**RE: RESPONSES TO REQUEST FOR ADDITIONAL INFORMATION ON
CRYSTAL RIVER PLANT UNITS 4 AND 5
FGD BLOWDOWN PONDS
SITE CERTIFICATION MODIFICATION N**

Golder Associates Inc. (Golder), with input from Progress Energy Florida (PEF) has prepared the following responses to the request for additional information (RAI) from the Florida Department of Environmental Protection (FDEP) dated July 24, 2009. The numbering of the responses corresponds to the numbers in the RAI:

SHT 8 OF 15 DWG NO: 8 REV: 1

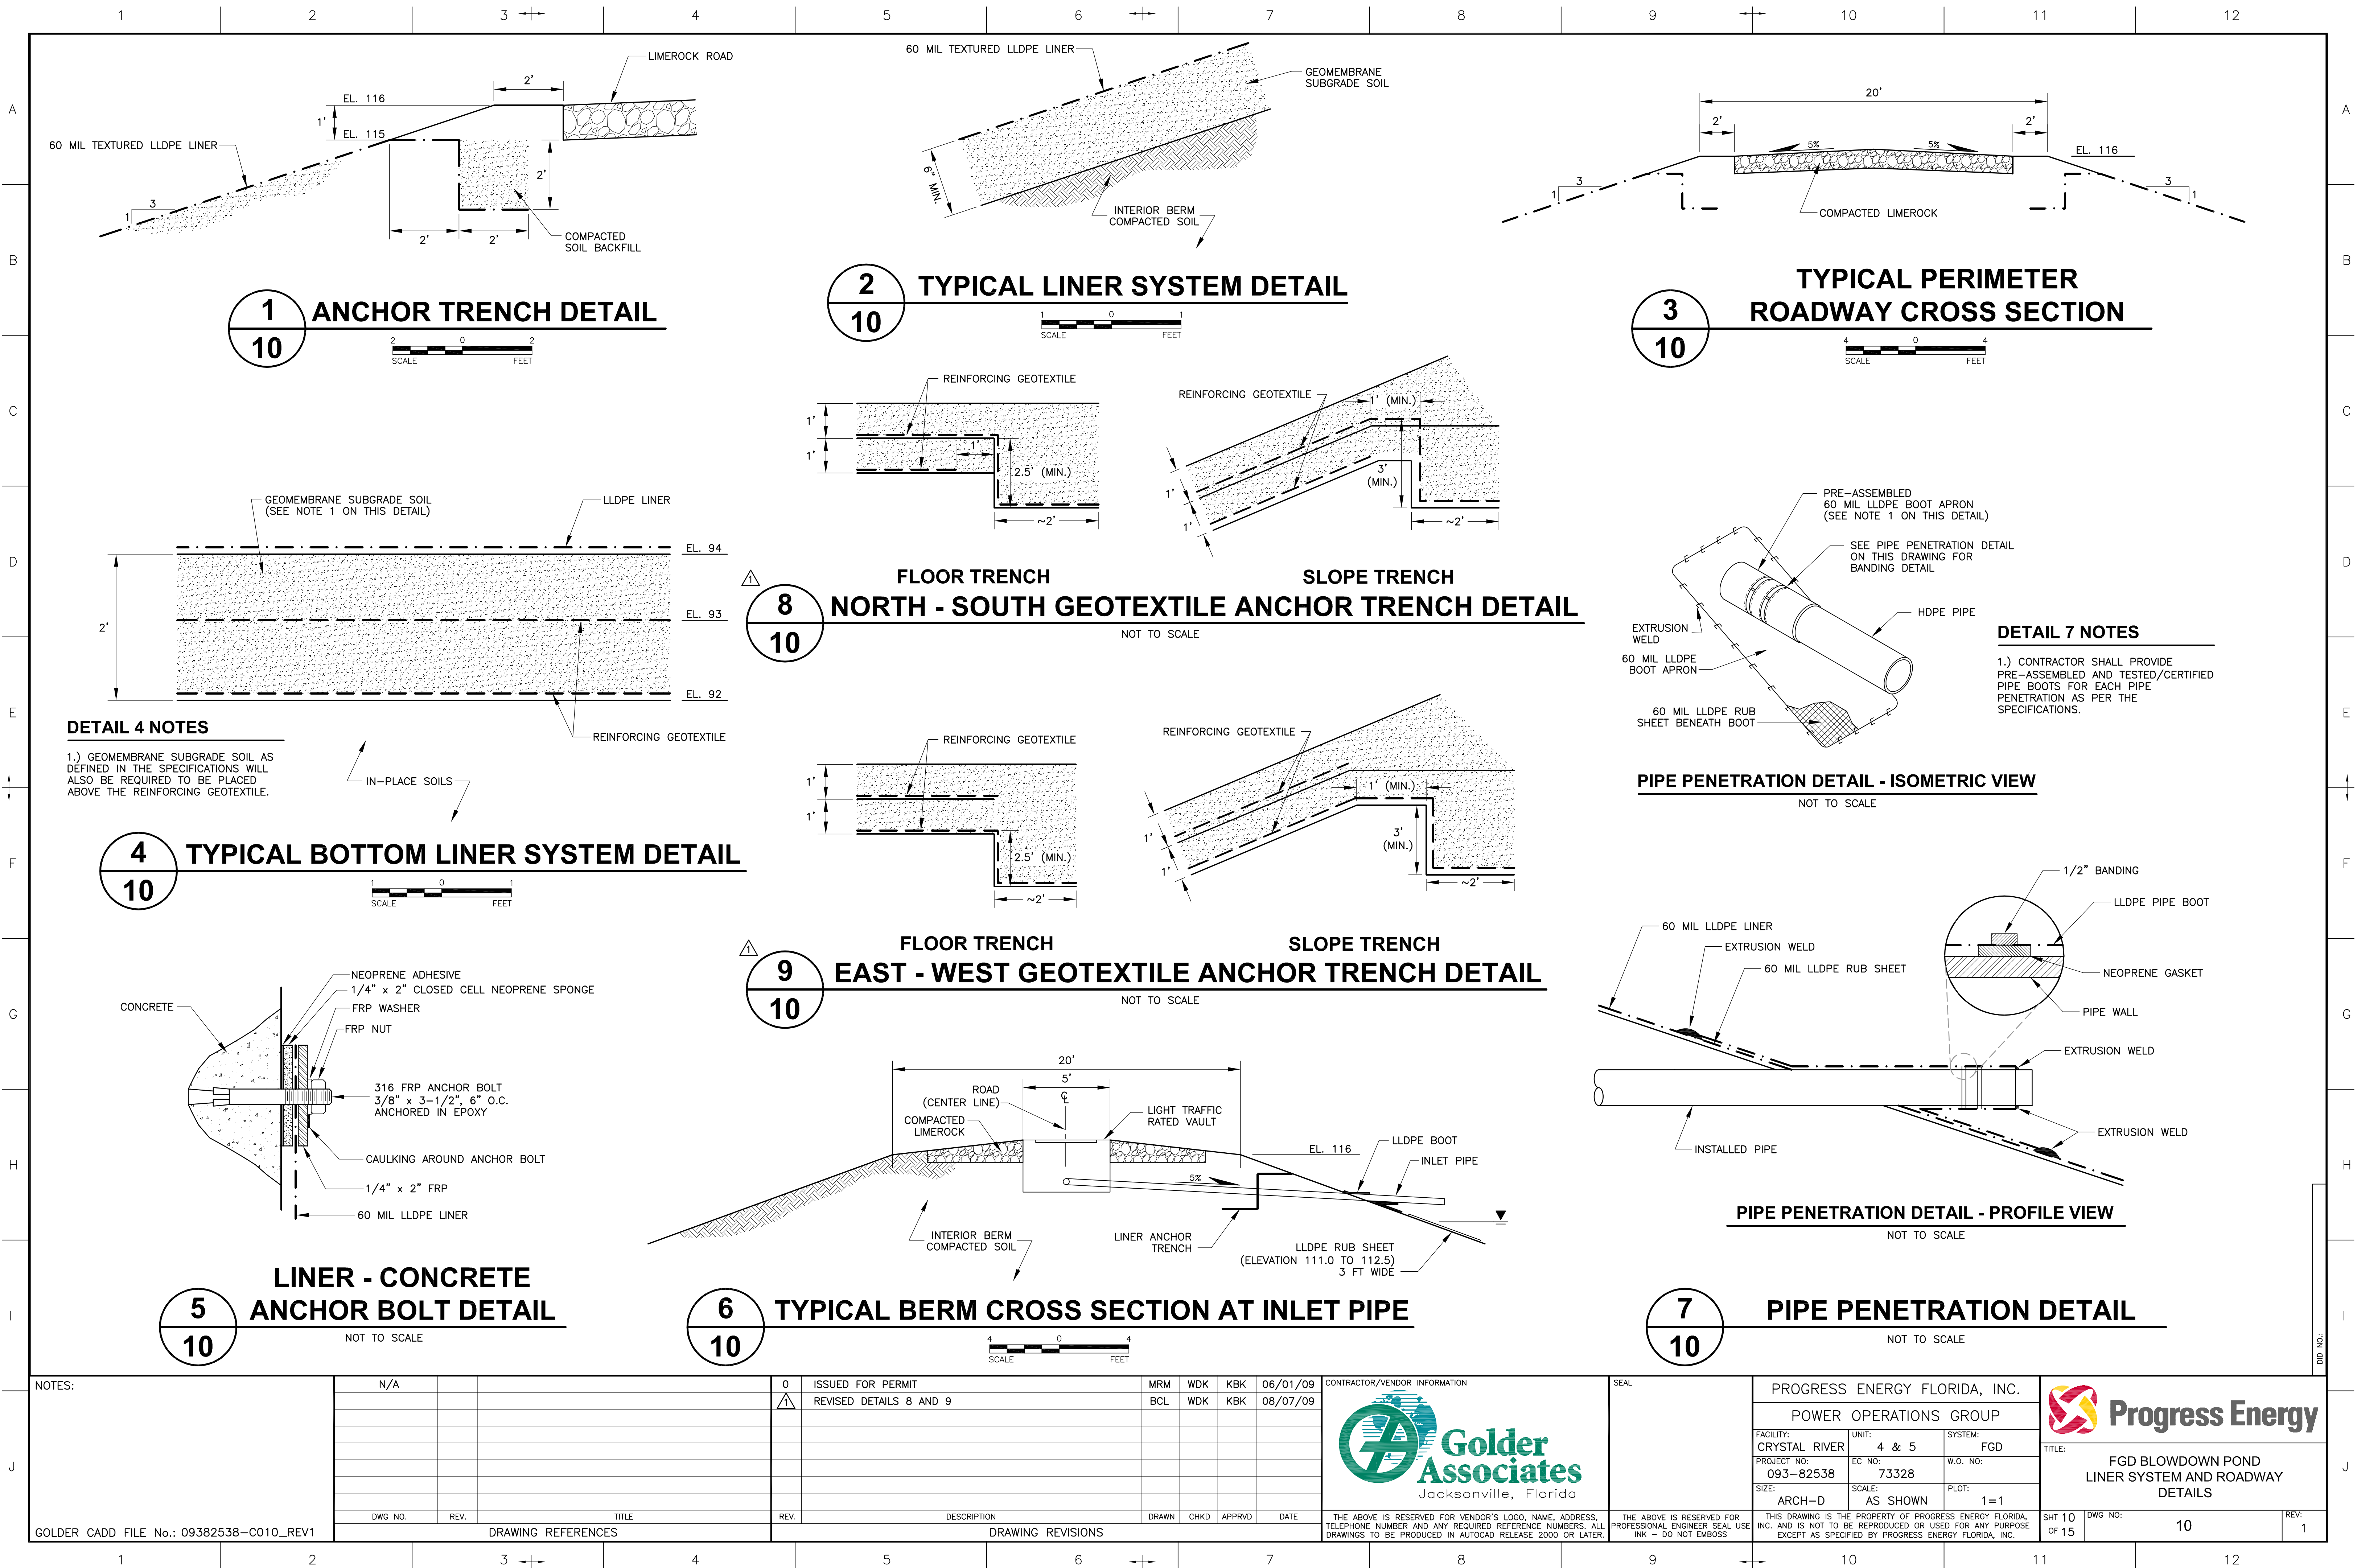
³ See footnote 2 – Drawings 7 and 8 are revised accordingly.

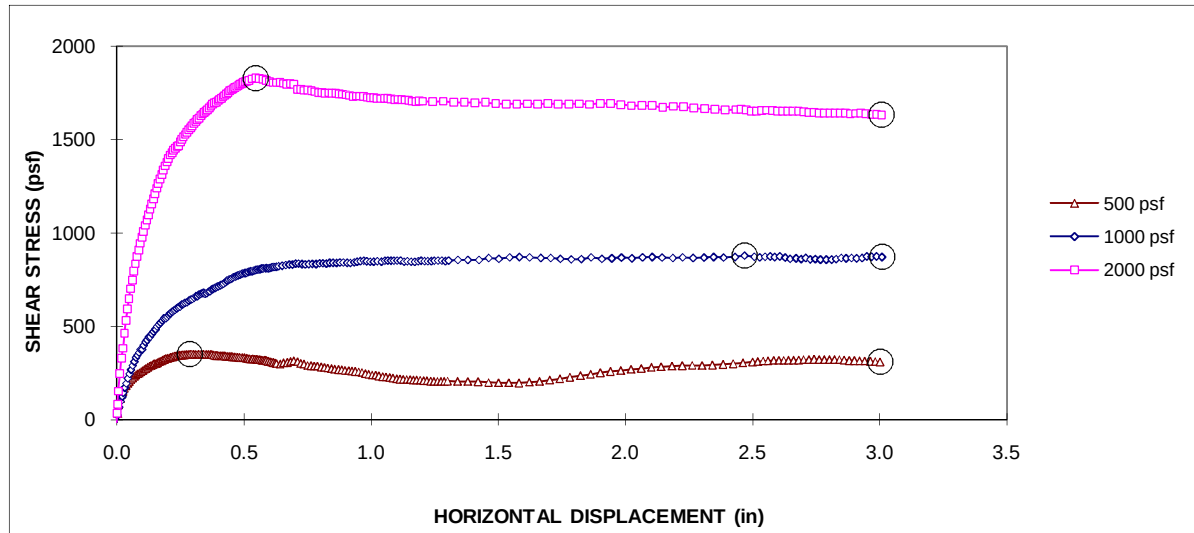
15. The following provide responses to the referenced details on Drawing 10; no revision was made to this drawing based on these comments.
 - a) Refer to the response to number 3 above.

- b) The detail accurately depicts the reinforcing geotextile configuration where the east-west or north-south running panels are not anchored on the north/south or east/west, respectively. The reasoning behind not anchoring the material on the sides of the end panels is that the reinforcing characteristics intended to be required for this project are only in the machine direction (not the cross direction), thus anchoring for the purposes of tensioning the fabric in the cross direction is not necessary.

- b) To reflect the revised calculations as discussed in a. above, Details 8 and 9 have been revised. The revised Drawing 10 is included in Attachment C.
